# Development Permit Panel Wednesday, November 27, 2024

#### 1. DEVELOPMENT PERMIT 17-772227 (REDMS No. 7782739)

Gladwyn Townhouses, 11671 Cambie Road, Richmond BC [DP 17-772227]

# **Overview - DP vs As-built Differences**

## B. Outdoor privacy screens extended past entry canopies

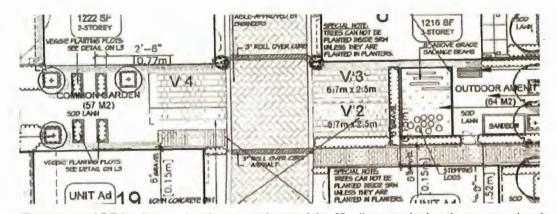
Similarly, along the Mellis Drive PROP pedway, the approved DP set notes that 6'h wooden dividers at Building 3 are only allowed under the covered entry porch, not to project into the open yard. Again, an oversight not working from this DP set, the 6'h wooden dividers do extend past the shallow canopies but help to visually screen the patios. They also provide a solid noise barrier for the condenser units in each yard. <u>After city review, these are left at 6'h tall</u>.

D. Drive aisle crossing was not raised - speed bumps added in lieu

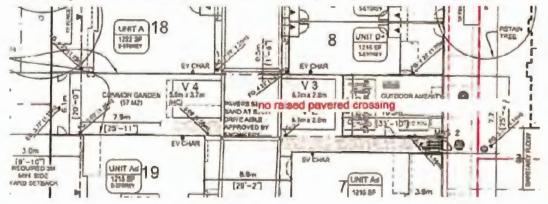
The approved DP landscape drawing correctly noted the 3" rollover curbs but the approved arch DP drawings do not. Somehow, the note for the raised pedway was inadvertently dropped.

# E. Revised some cladding materials to suit marketing team concerns

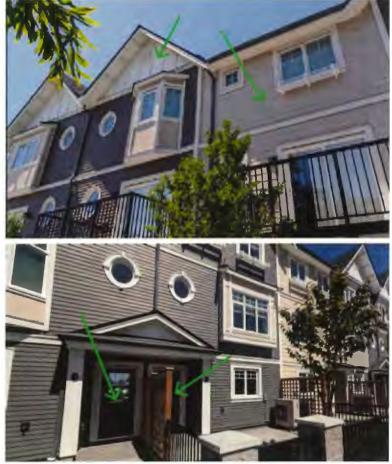
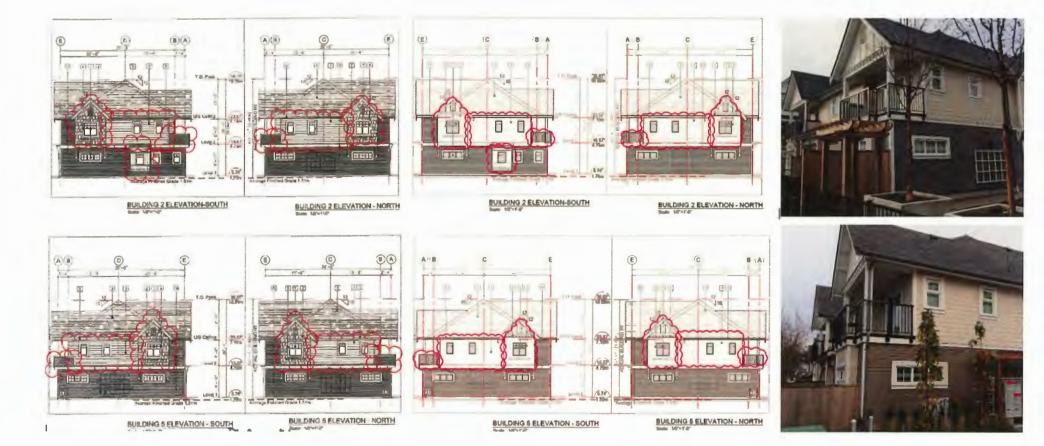
- a) Change from fibre-cement shingles to board & batten.
- b) Colour change to minor sections of horizontal 8" Hardie plank siding from BM CC-80 (gray mist) to an off-white tan colour. The gray was deemed too dark for the market.
- c) Colour change of entry doors from bright red (BM CC124) to more muted darker red/brown.
- d) Building 2&5 balcony pony wall was changed to aluminum guard rails
